SUBJECT
N14 and N18 Engine: High-pressure Pump Repair Instruction
MODEL

INFORMATION

Continental High-pressure Pump (1):

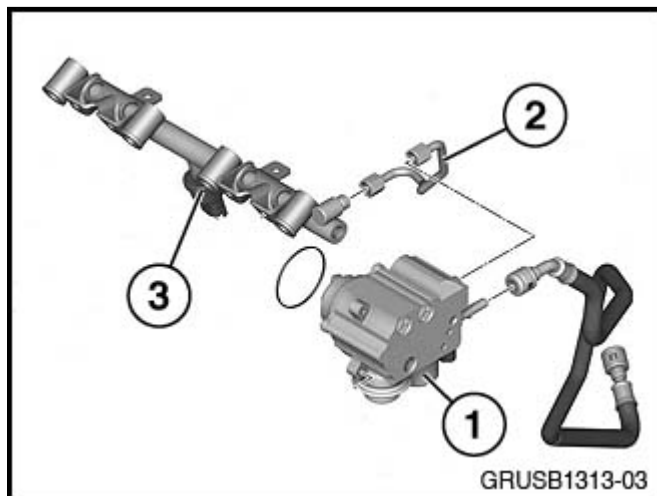
The current version of ISTA/D Repair Instruction 13 51 017, “Removing and installing or replacing high-pressure pump (N14, N18)” has a procedure error. The current version of the Repair Instruction states to replace the high-pressure supply hose on the N14 engine. The Repair Instruction also states not to replace the high-pressure supply hose on the N18 engine. The N18 portion of the Repair Instruction is incorrect. As an interim solution, follow the procedure outlined below until this portion of the Repair Instruction is corrected.

All vehicles equipped with the N14 engine (all production)
 All N18 vehicles produced to 3/2012 are equipped with a Continental High-pressure Pump.
 When the N18 engine is fitted with a Continental High-pressure Pump (1), the high-pressure supply hose (2) **MUST** be replaced when making repairs.

**Bosch High-pressure Pump (1):**

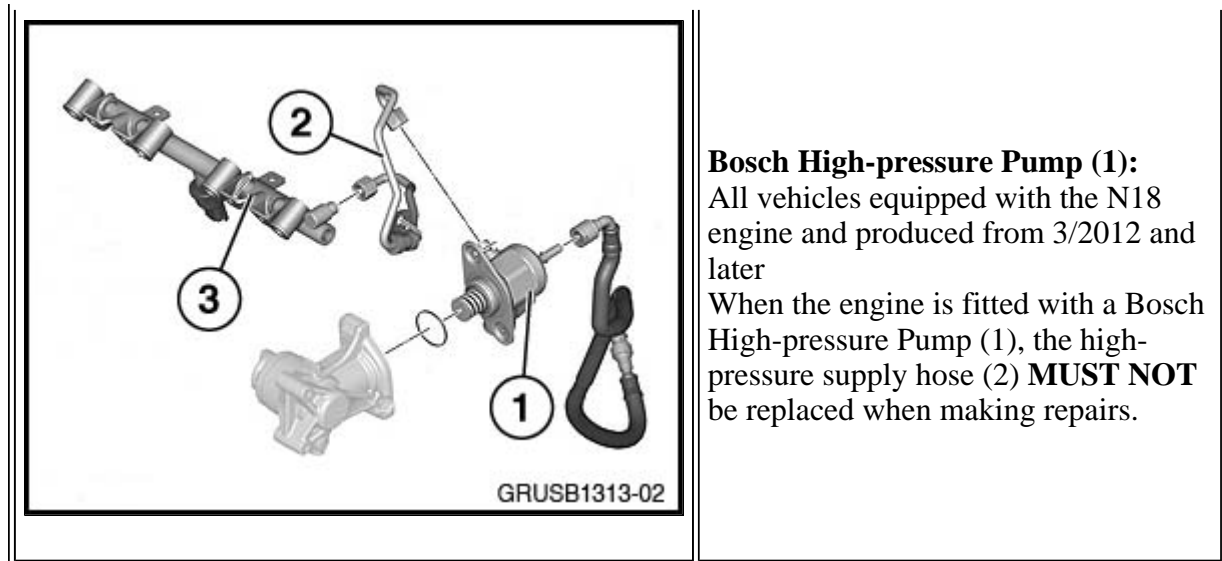
All vehicles equipped with the N18 engine and produced from 3/2012 and later

When the engine is fitted with a Bosch High-pressure Pump (1), the high-pressure supply hose (2) **MUST NOT** be replaced when making repairs.
